Planning Commission Hearing Staff Report

Planning and Zoning Division
Department of Community &
Economic Development

Autozone Planned Development
Preliminary Planned Development (Petition 410-08-39)
Located at approximately 1199 East 3300 South
Hearing date: September 10, 2008

3300 SOUTH STREET
LANDSCAPE PLAN

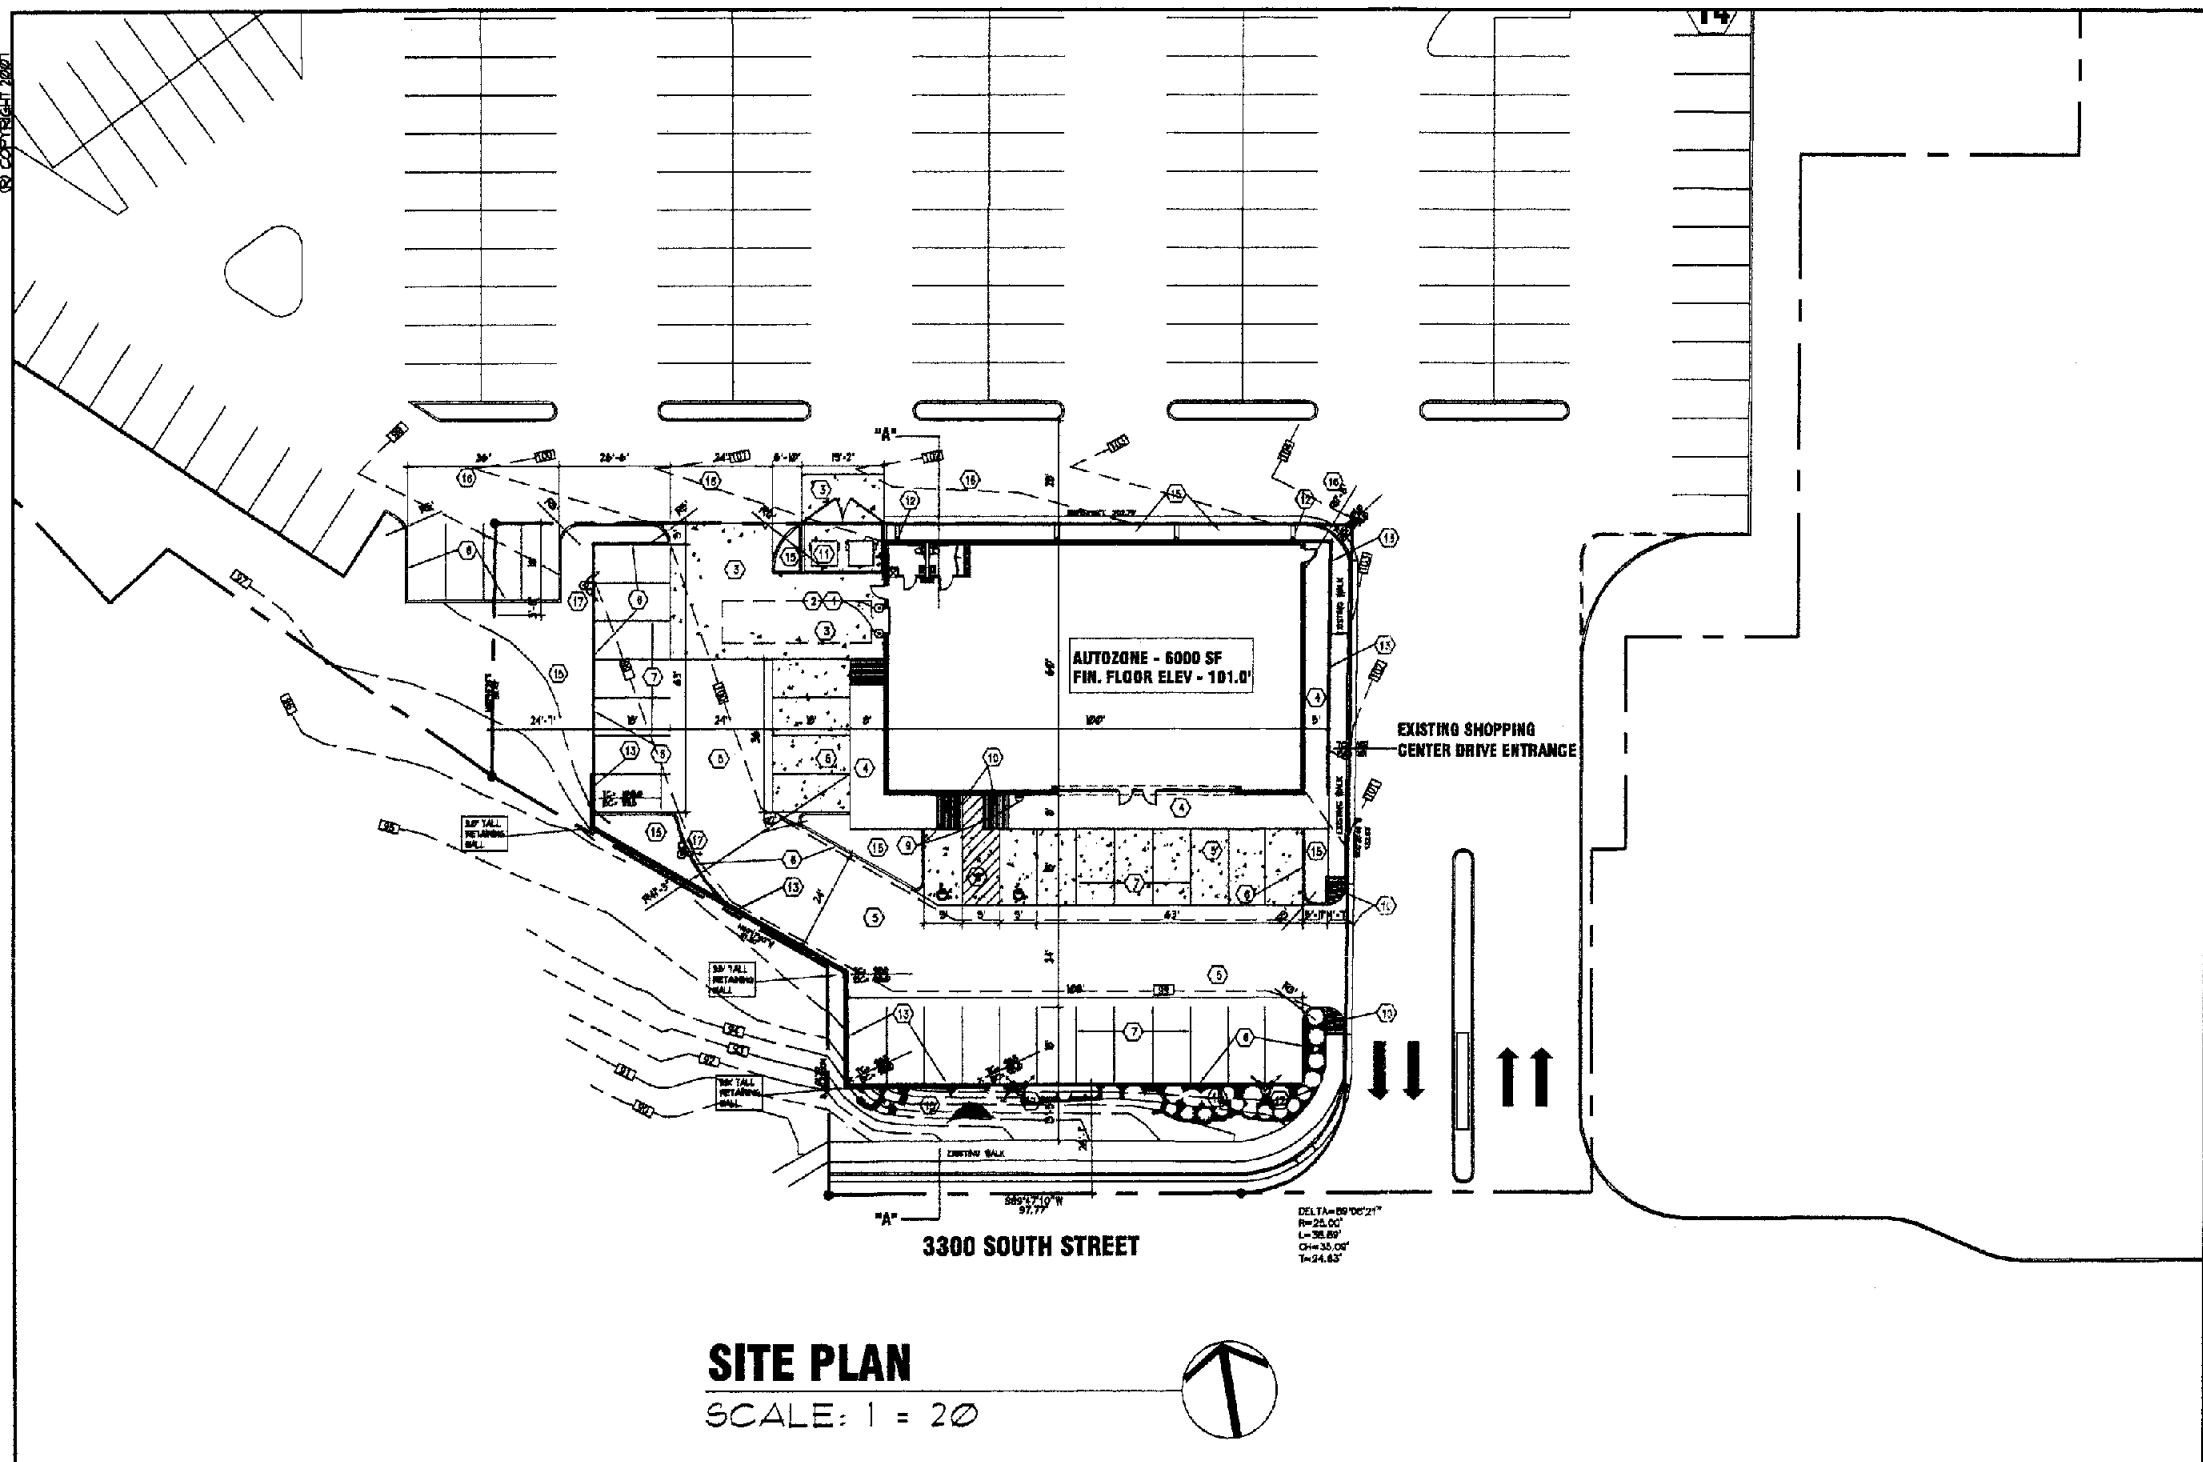
- **Perimeter Parking Lot Landscaping (21A.48.070.C.2):** When parking is proposed within a required yard or within twenty feet (20') of a lot line, perimeter landscaping shall be provided. The landscaping shall be provided with landscape areas at least seven feet (7') wide measured from the back of the parking lot curb. The proposed parking lot is five (5') feet from the interior side (west) lot line. The proposed landscape area is five feet rather than seven feet (7').

Given the vacant, undevelopable lot located to the west of the site, staff finds the enforcement of the 7-foot perimeter landscaping unnecessary in this location along the west property line.

Analysis: The parking lots will include landscaping to minimize potential impacts to the neighborhood. The Landscaping Ordinance stipulates a 7-foot perimeter parking lot buffer whenever the parking lot is within 20 feet of property lines. In one area of the site along the west edge, the landscape buffer proposed is approximately 5 feet rather than 7 feet. The requested reduction in landscape buffer width is minimal and adjoins vacant property that is considered undevelopable due to a fault line running through the property. The parking lot does not create any adverse impacts to the adjoining property or the neighborhood. The retaining wall separating the sidewalk and the parking lot will be terraced and landscaped to reduce its visual impact on vehicle and pedestrian traffic along 3300 South. The project should be held to the minimum 5% interior parking lot landscaping by adding 250 square feet additional landscaping to the parking areas – preferably the southern parking area, or by replacing the 12 parking stalls along 3300 South with landscaping.

1. Extension of the maximum front yard building setback from 15 feet to 92 feet as shown on landscape plan.
2. Reduction from 7 feet down to 5 feet for width of required landscape buffer along west edge of west parking area that is within 7 feet of property line as shown on the applicant's landscape plan.
3. Grade changes up to but not more than 6 feet for the proposed retaining wall along 3300 South.

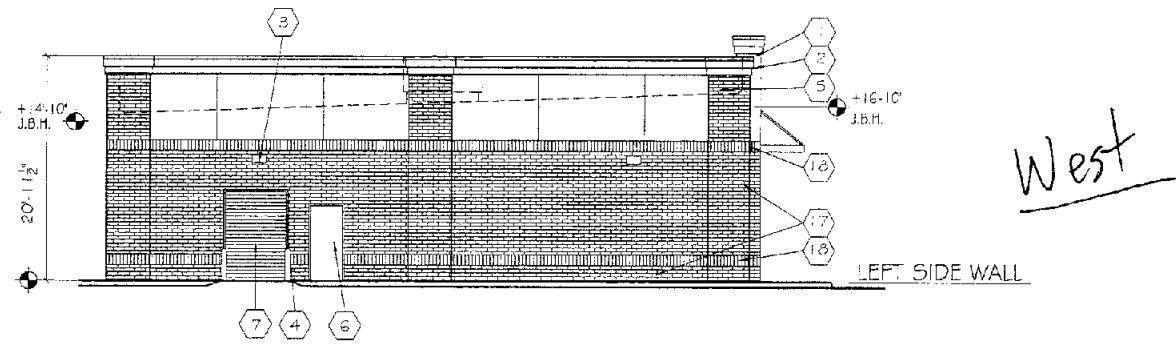
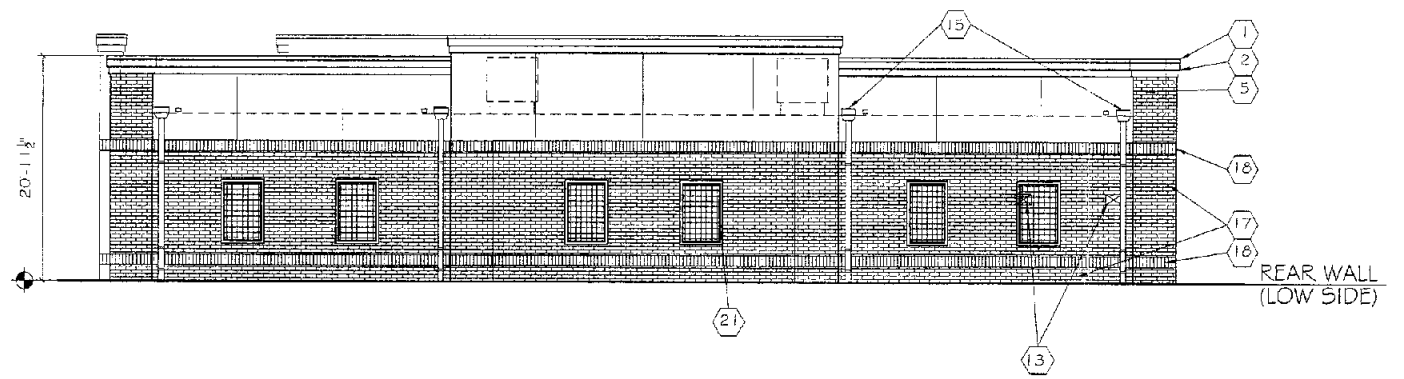
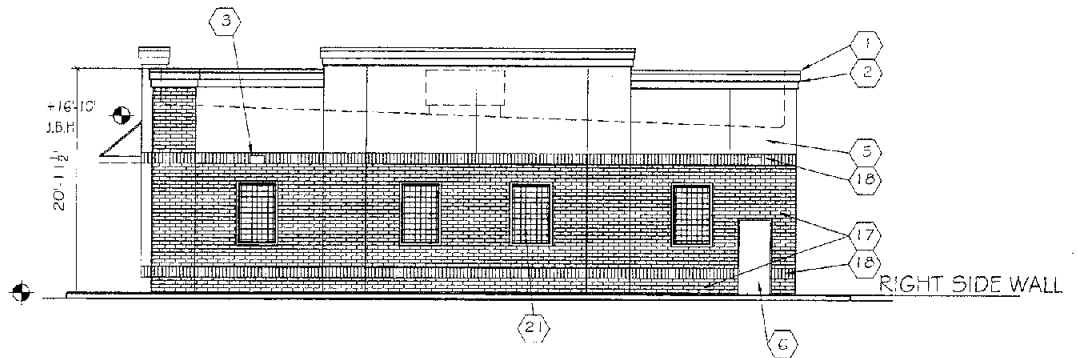
- **Minimum First Floor Glass (21A.26.030.I.1):** The building facade facing 3300 South is required to have a minimum of forty percent (40%) non-reflective glass. The proposed façade contains approximately twenty-four percent (24%) glass.

The applicant has revised the building design to include more non-reflective glass up to twenty-four percent (24%) glass. The applicant claims that the amount of glass has to be limited because this type of retail use inventories a larger number of items and needs interior wall space to do so. Due to the glass content requirement, large inventory retail businesses such as this auto parts store will find difficulty in meeting the glass requirement.

NOTE: AREA OF B.O.S FACAD MINUS BUILD UP CORNICE = 2027 SF
 2027 SF x 40% = 811 SF GLAZING REQD.
 GLAZING PROVIDED = 487 SF
